1.1 ADDENDUM

1.2 MECHANICAL DRAWINGS

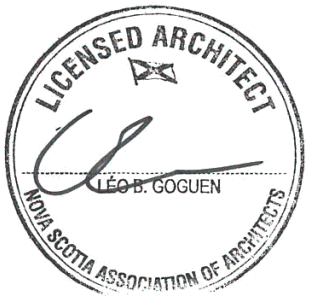
.1 Return fan RF-8 shall run when supply fan at AHU-1 is on.

.2 Transfer fan TF-1 shall be continuously on.
